Intel[®] 80331 I/O Processor

Specification Update

April 2006

Table 236. DDR SDRAM Control Register 0 - SDCR0 (Sheet 1 of 2)

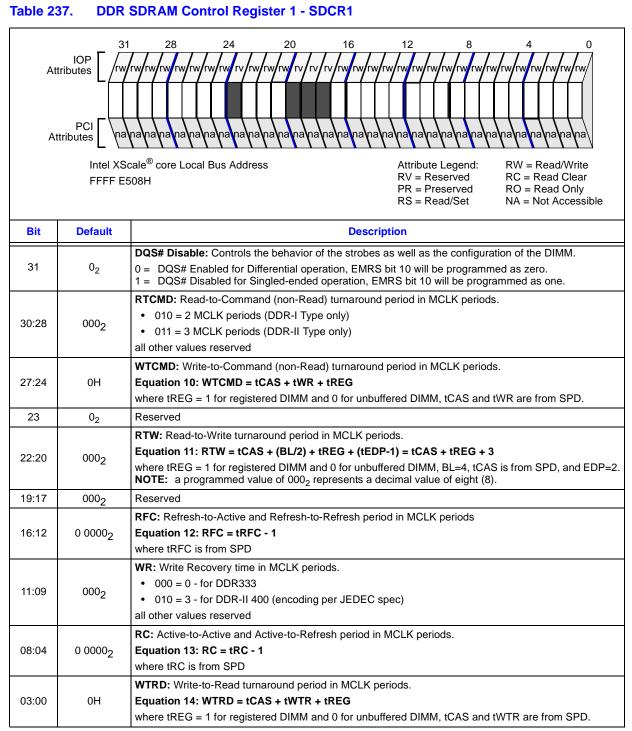
Workaround:

31:28	0Н	RAS: Active to Precharge duration in MCLK Equation 7: RAS = tRAS - 1 where tRAS is from SPD	periods	
27	0 ₂	Reserved		
26:24	000 ₂	RP: Precharge Command Period in MCLK p Equation 8: RP = tRP - 1 where tRP is from SPD	eriods	
23	0 ₂	Reserved
